PROJECT:
P500 House Type 2

DESCRIPTION:
House Type 2 - Proposed Plans 01

PURPOSE OF ISSUE:
Planning

JOB NO: STATUS CODE: DRAWING NO: REV
3788 S2 156 D

House Type 2 - 3BH 96m² Ground Floor Plan
1 : 50

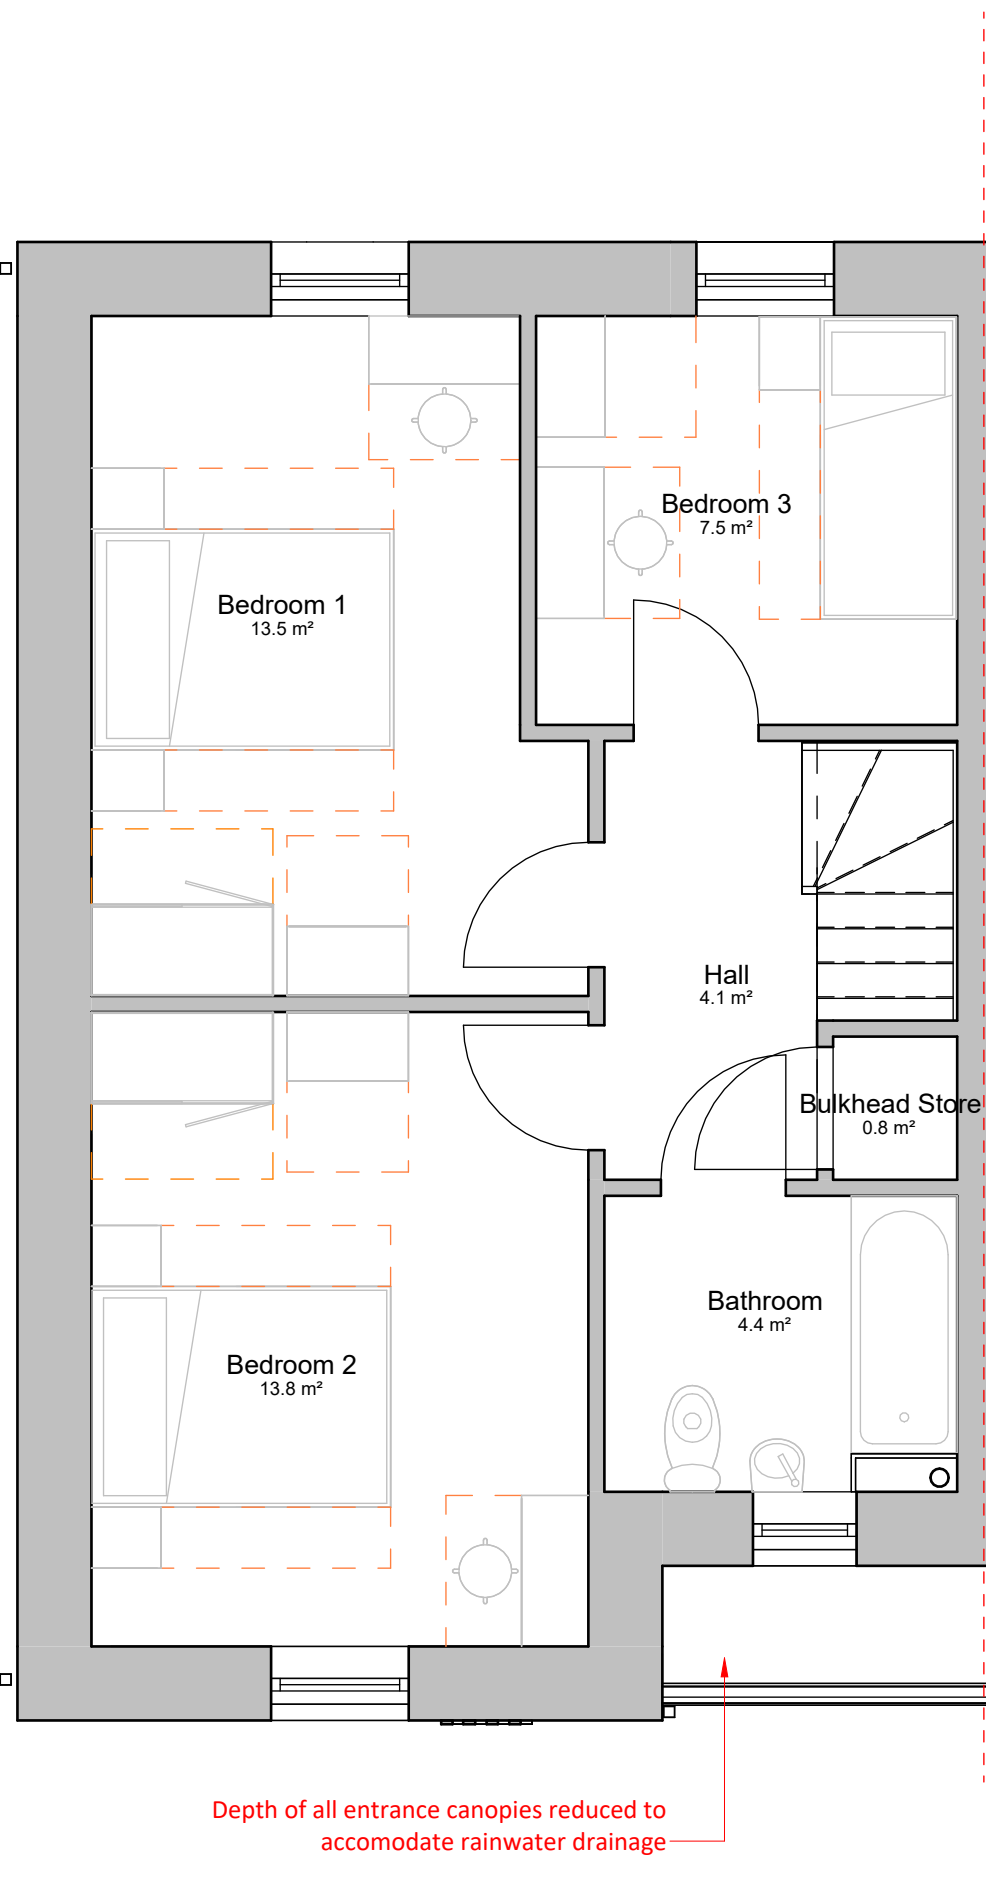
*Internal layouts updated to accommodate cylinder store.
1no. meter box to front of each unit removed in accordance with proposed installation of ASHP and MHVP system

House Type 2 - 3BH 96m² Roof Plan
1 : 50

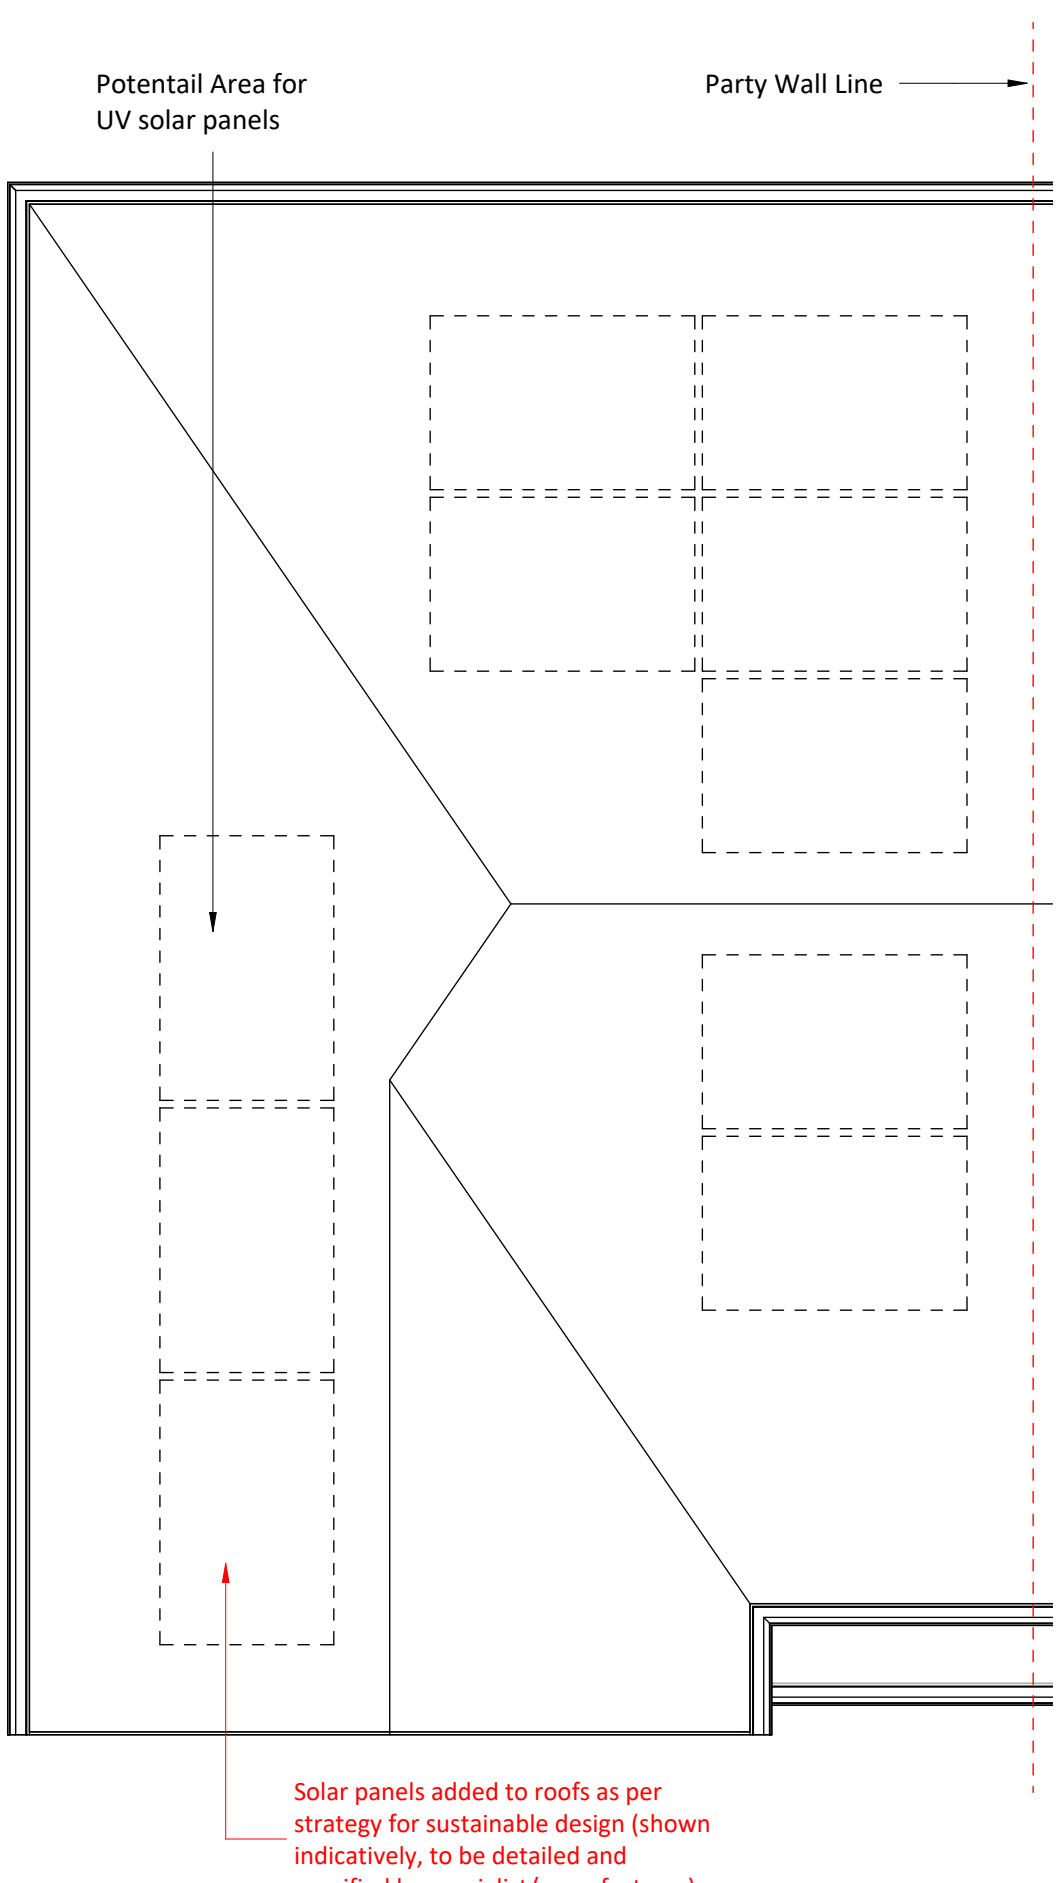
D	15.04.25	HG	Roof height amended to accommodate MVHR system in ceiling void in line with specialist feedback, prior to S73 application submission.
C	18.02.25	HG	Red annotations added to drawings to denote the changes made to the design as part of the NMA submission as requested by MCC.
B	11.02.25	HG	Drawing revised in line with client comments to determine levels and encapsulate all amendments for NMA submission
A	21.11.24	HG	Drawings revised in line with planning conditions and client feedback to form NMA
5	15.12.23	JW	GIA and Room Areas added to the drawings
4	12.12.23	JW	Indicative outline for UV solar panels added to roof plans
3	08.12.23	JW	Drawing package revised to show increased wall build-up and 195mm reveal
2	13.07.23	JW	House type updated following value engineering. Update of file identifier and title block. Information provided regarding bat and swift boxes inline with EM Ecology reports
